DOCUMENT CHANGE NOTICE (DCN)

DOCUMENT No. (DOC-REV-GP. ID)	TITLE	NEW REV.
D961434-A-D	Large Core Optic Component Carrier Standoff Assembly	B
D961435-A-D	Beam Splitter Optic Carrier Standoff Assembly	B
D961444-A-D	Large Core Optic Component Carrier Hinged Standoff Assembly	B
D961445-A-D	Beam Splitter Optic Carrier Hinged Standoff Assembly	B
D961454-A-D	Large Core Optic Component Carrier Indexed Standoff Assembly	B

LARGE CORE OPTIC COMPONENT CARRIER STANDOFF ASSEMBLY

DRG NO: D961434-B-D SHEET 1 OF 1

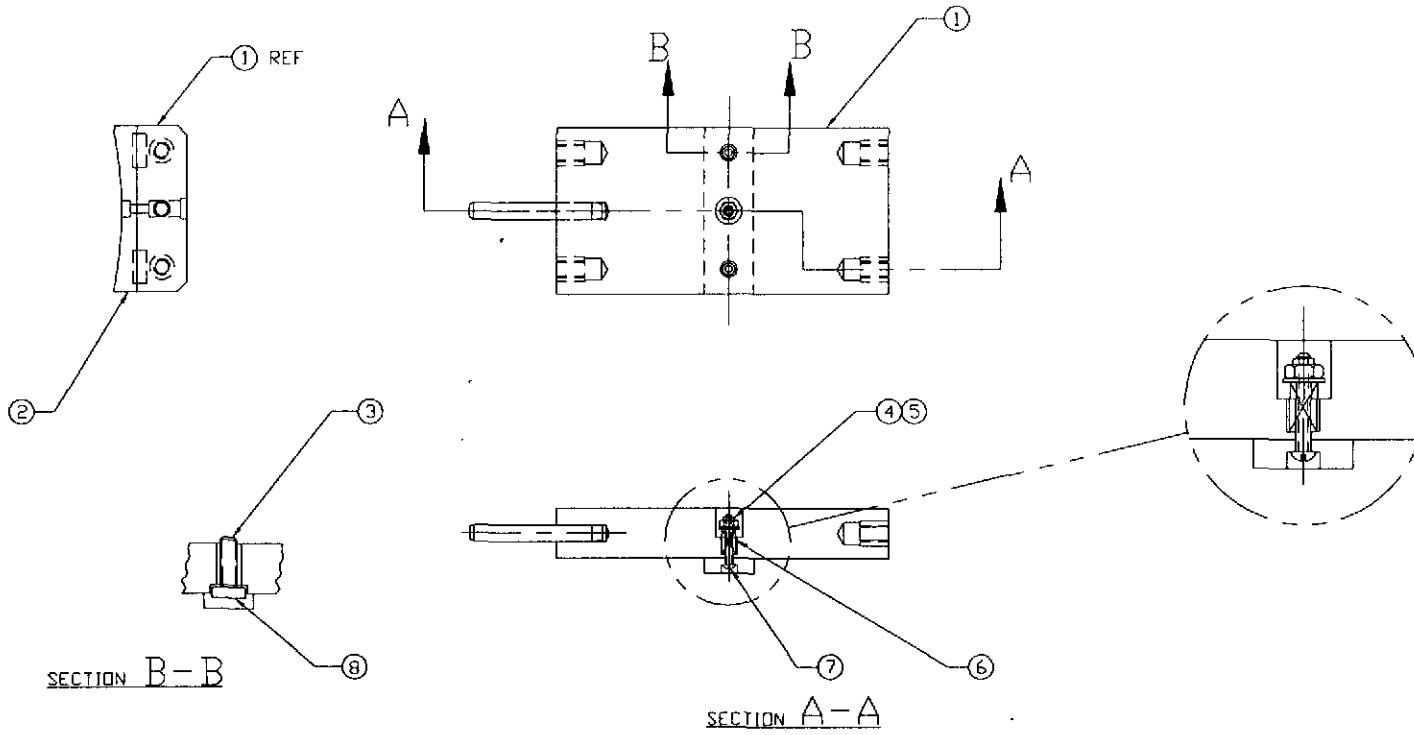
D961434, D961435, D961454, D961455:

In parts list, changed item 3 description from:

McMaster-Carr #92765A999 1/4-20 x .75 lg oval point soc set scr

to:

McMaster-Carr #92765A999 1/4-20 x .625 lg oval point soc set scr

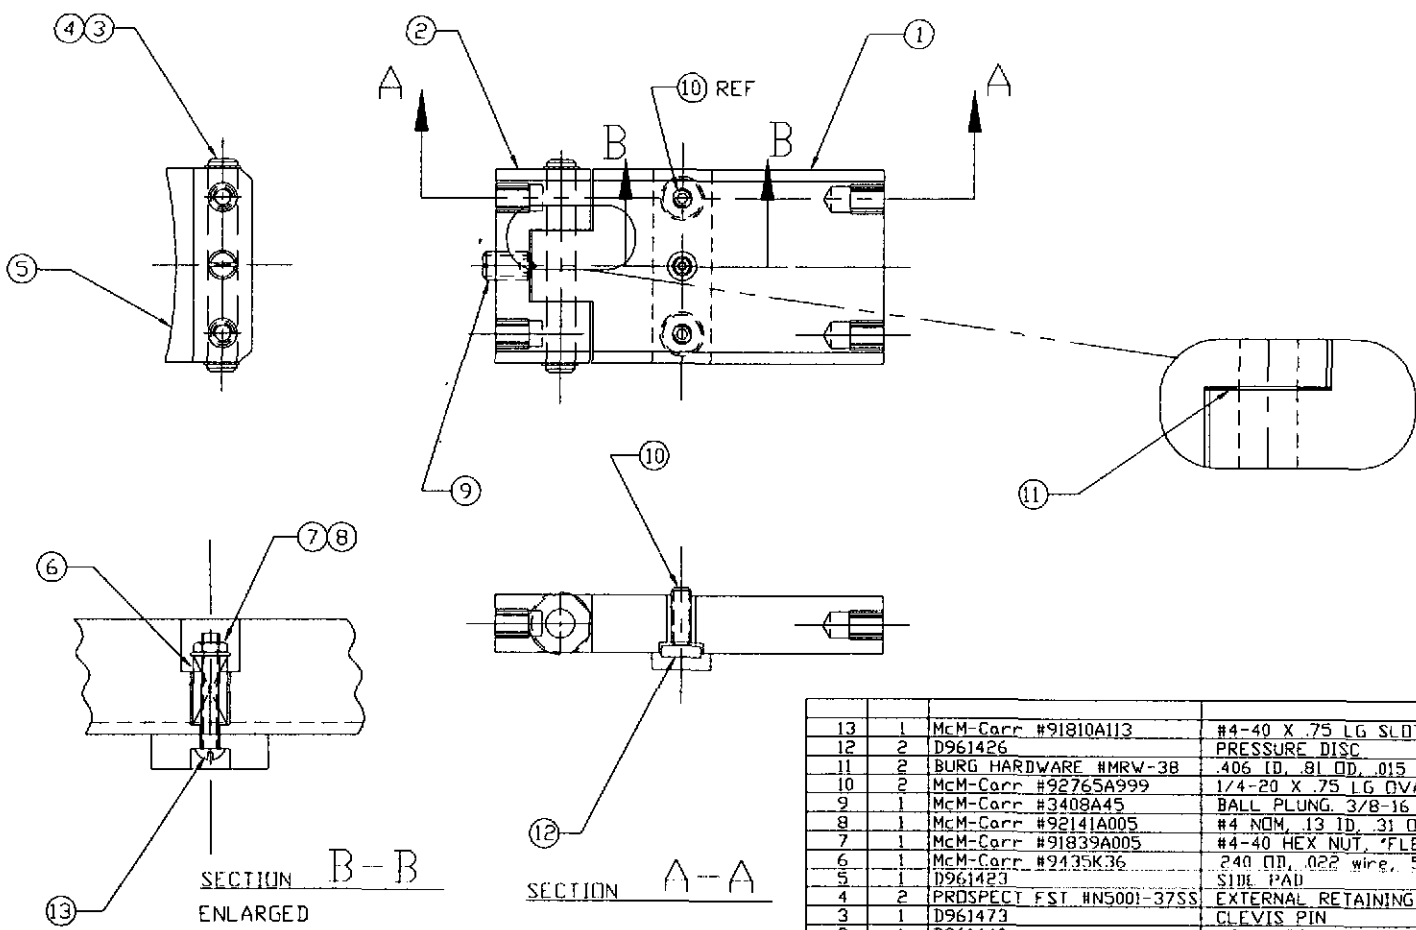
D961444, D961445:

In parts list, changed item 10 description from:

McMaster-Carr #92765A999 1/4-20 x .75 lg oval point soc set scr

to:

McMaster-Carr #92765A999 1/4-20 x .625 lg oval point soc set scr
